1984 - 1987 Corvette: Service Bulletin: Rattle From Turn Signal Lever

Subject: Rattle From Turn Signal Lever

Model and Year: 1983 - 1987 Chevrolet Vehicles with Multi-Function Turn Signal Levers

Bulletin Number: 87-224, Section 10

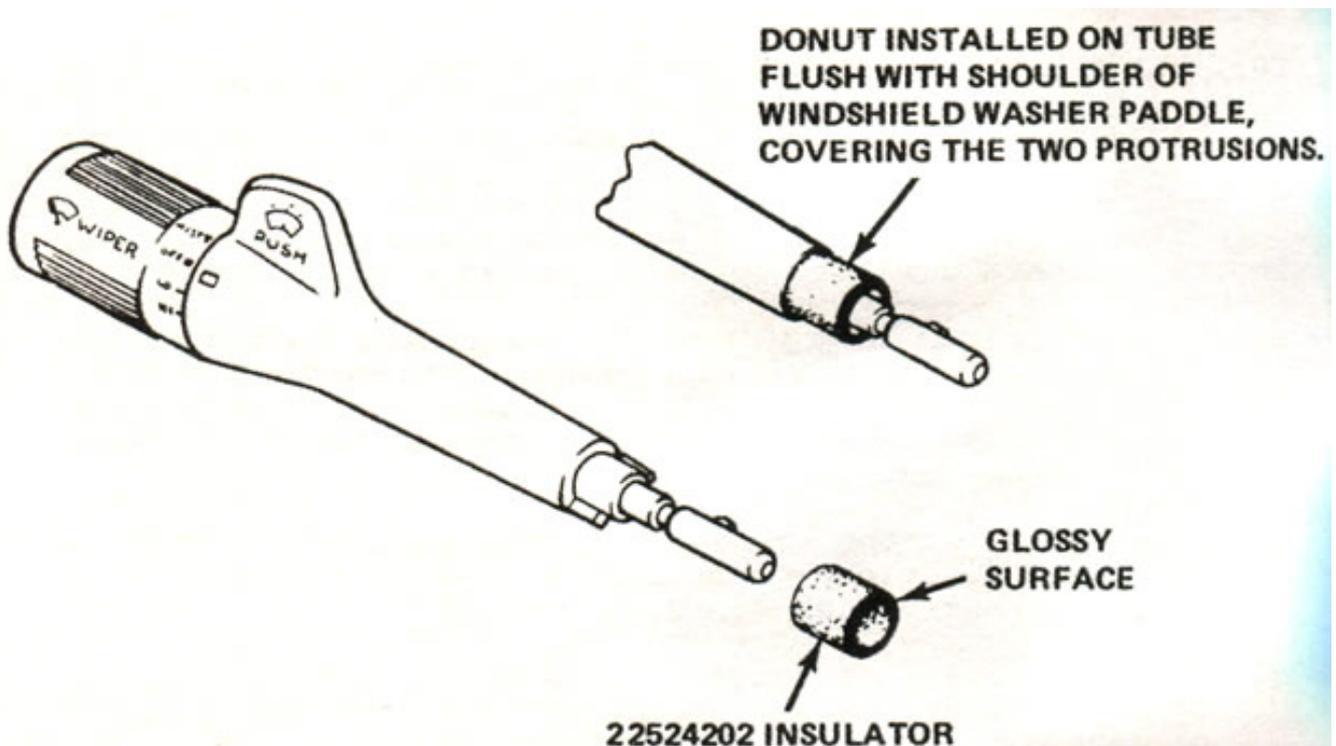
A rattle-type noise originating from the multi-function turn signal lever may be caused by excess looseness or play in the windshield washer actuator paddle.

This condition can be repaired by installing a foam rubber "donut" on the lever using the following procedure:

1. Make sure the lever is in the center or "off" position (turn signal not on).
2. Make sure that the windshield wiper switch is set to the "off" position. This must be done to prevent damage to the windshield wiper switch.
3. Pull the lever straight out from the column, using care not to pull any excess amount of wire from the column on cars equipped with cruise control.
4. Check the inner end of the lever for presence of a previously installed foam "donut". Also check in the steering column opening for a "donut" which may have been mis-installed during assembly.
5. If a "donut" is present, and it is not damaged, it can be re-installed. If the "donut" is damaged or missing, a new part can be obtained through GMSP0:

6. Install the foam "donut" to the turn signal lever as shown on the illustration, making sure that the "donut" is positioned over the two (2) protrusions at the end of the windshield washer paddle and flush against the shoulder of the paddle. NOTICE: The "donut" has a glossy appearance at one end. It may be easier to install the "donut" with the glossy end AWAY from the shoulder of the paddle.
7. Re-assemble the turn signal lever assembly to the steering column by pushing it back into the turn signal switch. Check the lever for proper function of all switches.
